## Stag Brewery

Masterplan and Detailed Design and Access Statement Addendum

ORIGINAL PROPOSAL: BUILDING 2 TYPICAL FLOOR PLAN (16 units/ 53 habitable rooms per level)

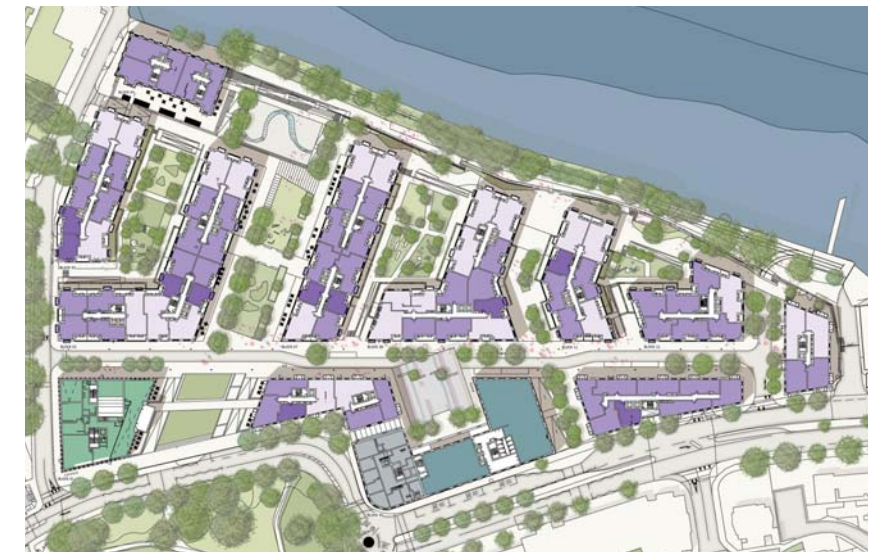
- Building 2 has been redesigned to optimise the residential floor area and remove one of the three cores. This has resulted in a slightly different ground floor level entrance configuration. It has also resulted in one of the cores at the typical level serving 9 units and the other serving 8 units (as opposed to 5, 5 and 6 units per core). The benefit of this layout is an optimised GIA and number of habitable rooms per level (increase from 53 in addendum application to 54 per level in revised). The cumulative changes to this building (including height) have resulted in an uplift of 80 habitable rooms (from 321 to 401) and as a consequence have significantly increased the scheme's ability to deliver a higher percentage of affordable housing by habitable room count.

REVISED PROPOSAL: BUILDING 2 TYPICAL FLOOR PLAN (17 units/ 54 habitable rooms per level)

ORIGINAL PROPOSAL: DEVELOPMENT AREA 1 TYPICAL FLOOR PLAN

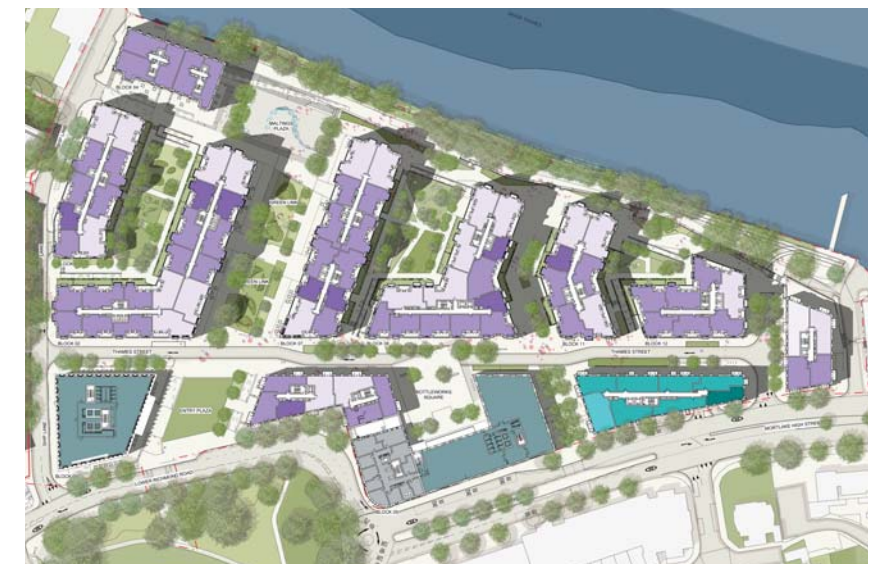
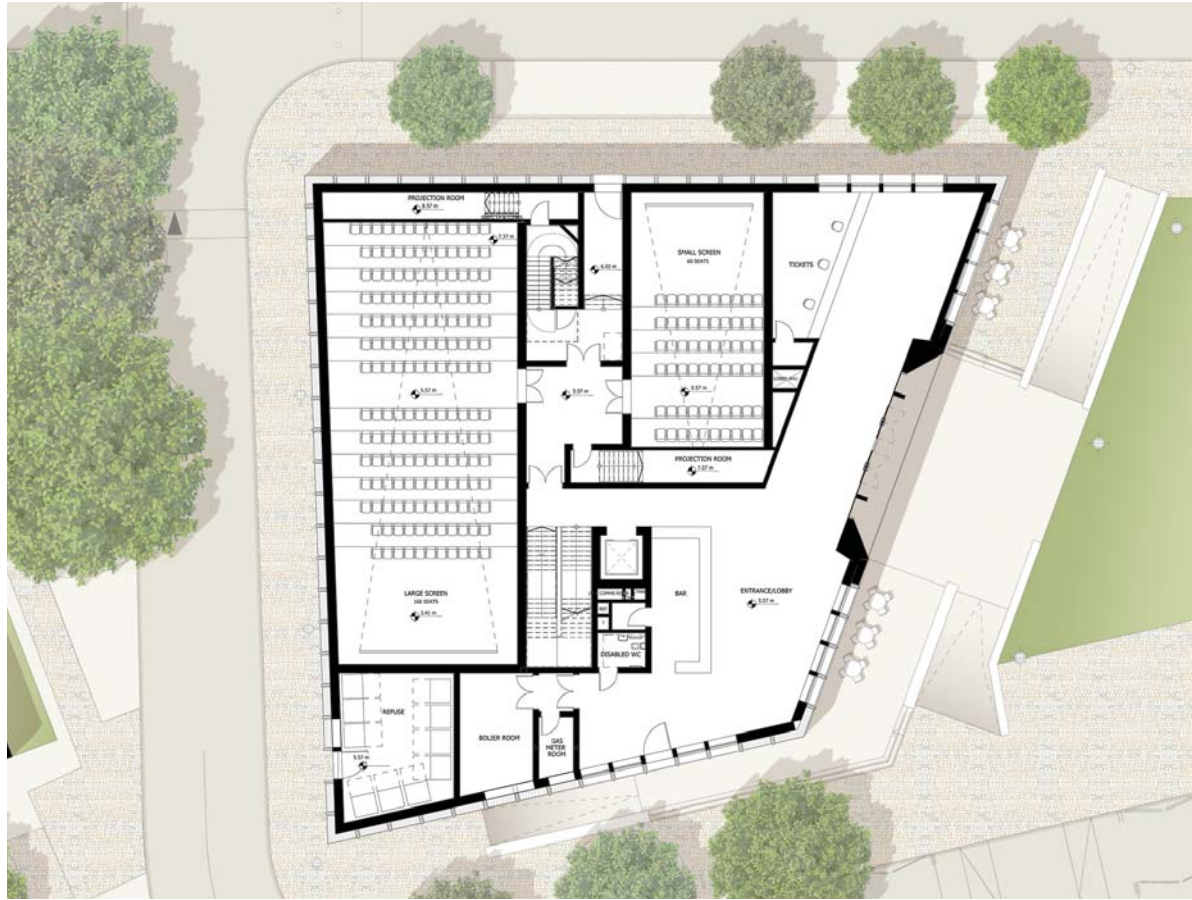
The main changes to the warehouse typology residential buildings is to Building 10, which has been re-configured to incorporate an appropriate mix of intermediate units (less three bedroom units) and optimise the efficiency of the layout to improve the habitable room count. There have been more minor amendments to the layouts of Building 6.

REVISED PROPOSAL: DEVELOPMENT AREA 1 TYPICAL FLOOR PLAN

ORIGINAL PROPOSAL : BUILDING 1 (CINEMA) GROUND FLOOR PLAN

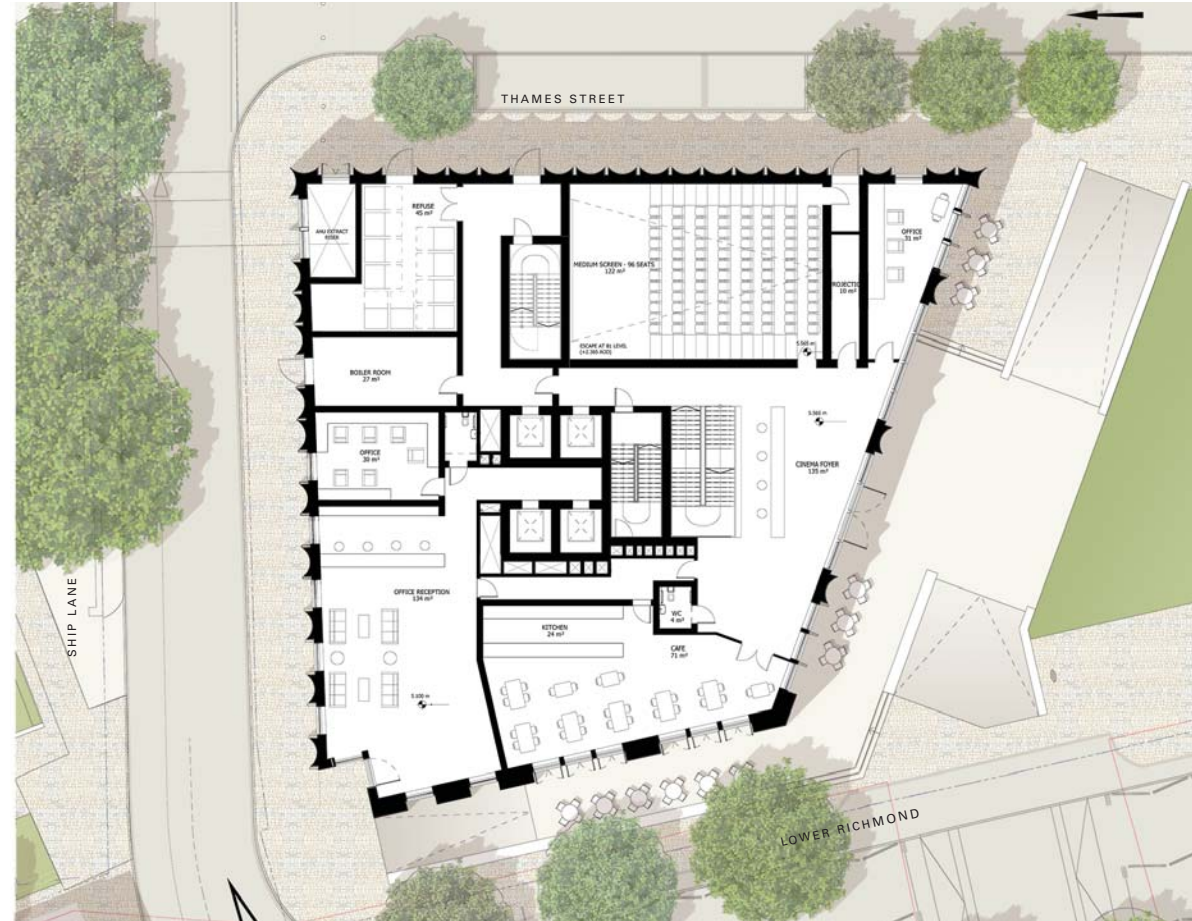
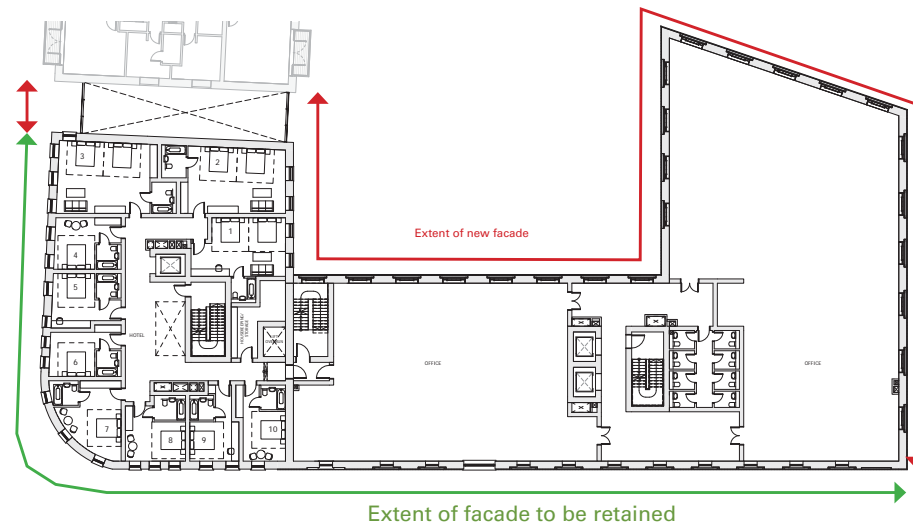
The standalone cinema building has remained the same in terms of footprint, but has been re-designed to serve as a mixed use building containing both cinema and office space.

The cinema accommodation has been condensed into two storeys of accommodation, the lower of which will sit at a lower ground floor level. The office accommodation will sit above the cinema space and be accessible via a ground floor level reception area at the junction of Lower Richmond Road and Ship Lane. Increased active frontage in the form of a small cafe (serving both cinema and office facilities as well as the general public) will be provided at ground floor level facing Lower Richmond Road. The cinema entrance will remain facing the entrance to the Green Link.

REVISED PROPOSAL: BUILDING 1 (CINEMA) GROUND FLOOR PLAN

ORIGINAL PROPOSAL: BUILDING 5 FIRST FLOOR PLAN

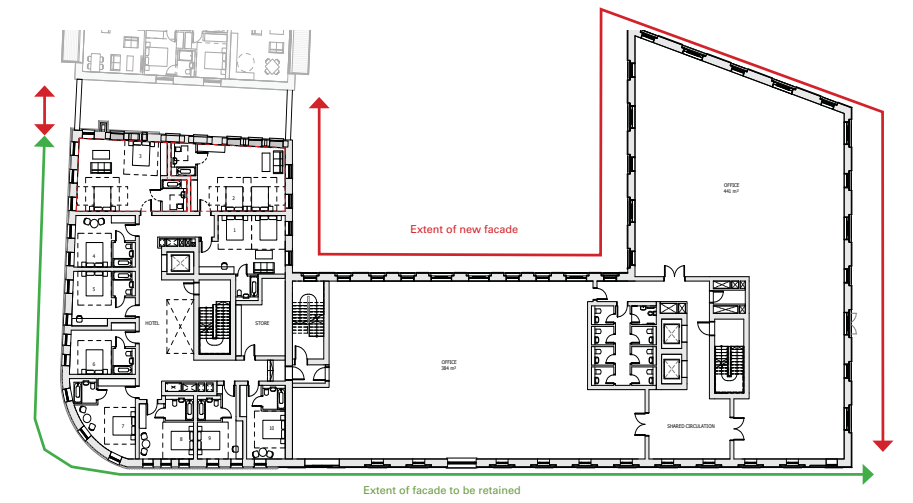
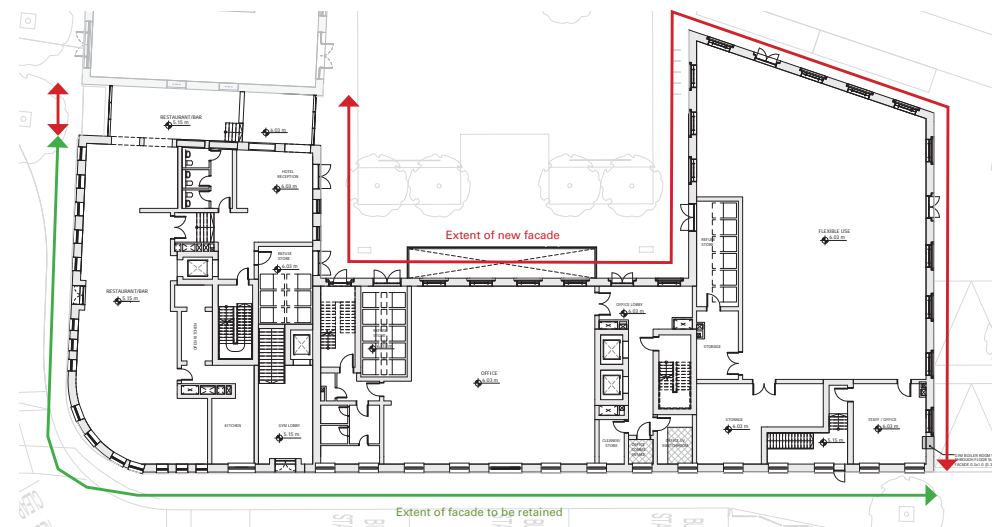
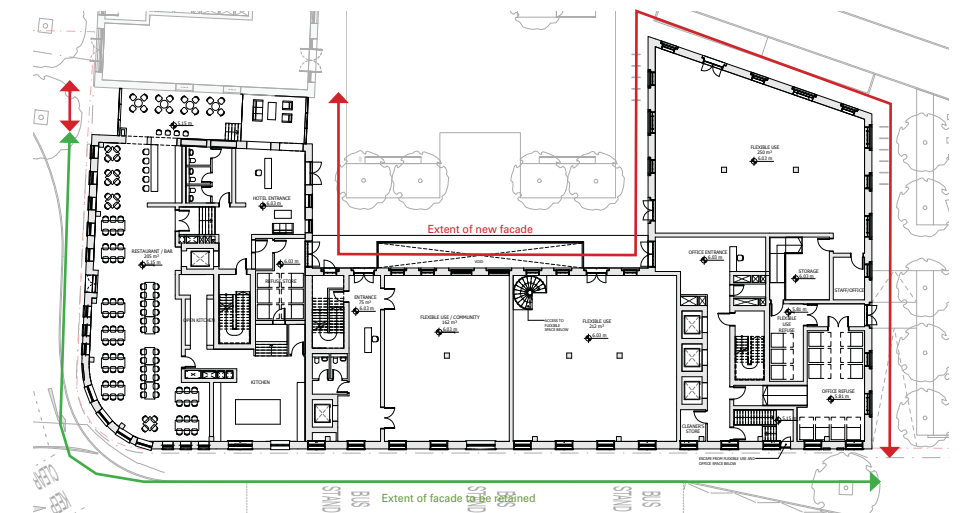
Building 5 has been revised slightly to remove the Gym use and increase the flexible use at ground and lower ground levels. The proposed footprint and extent of facade retention remains the same as previously proposed with only minor changes to the elevations.

REVISED PROPOSAL: BUILDING 5 FIRST FLOOR PLAN
